insPYRE Planning Development Request

STAFF COMMENTS:

10-C-25-SU
8/25/2025

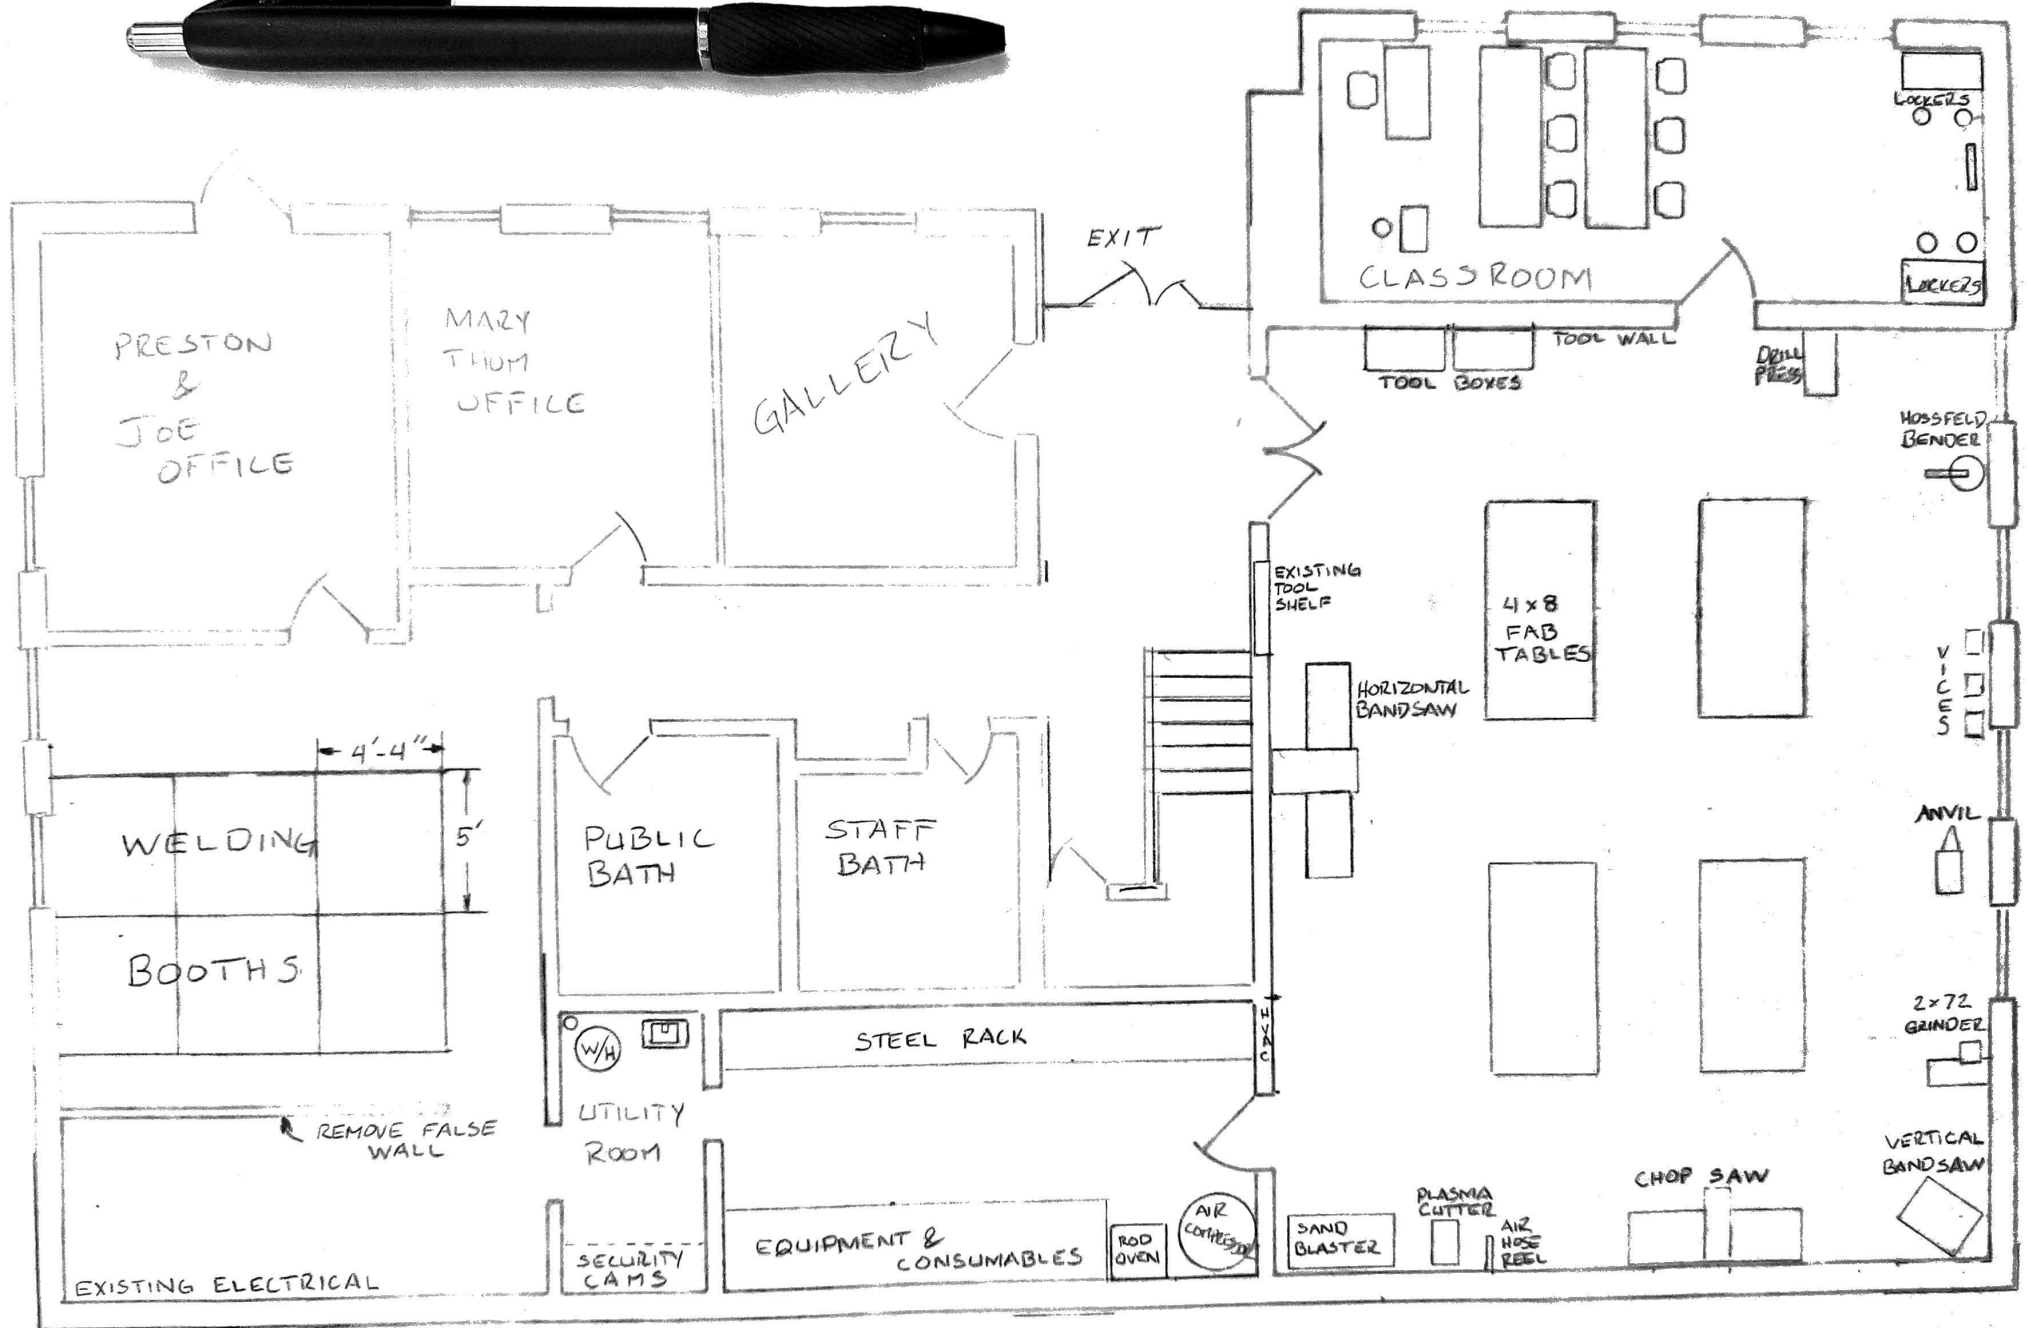
the layout of the space in relation to the residential use to the west, and explanation of extraction units, such how they will be utilized and where they exhaust.

a. I assume the room with the fab tables is where the noisiest part of the training happens and is on the opposite side of the building from the residents.

You are correct that the fabrication room will be on the far side of the building from the residents.

Our use of tools and ventilation should not generate noise that would go beyond our building.

The extraction units are self contained and will filter the air back into the room. Lincoln Electric has assured us the filters will be more than sufficient even if working with stainless steel or aluminum.
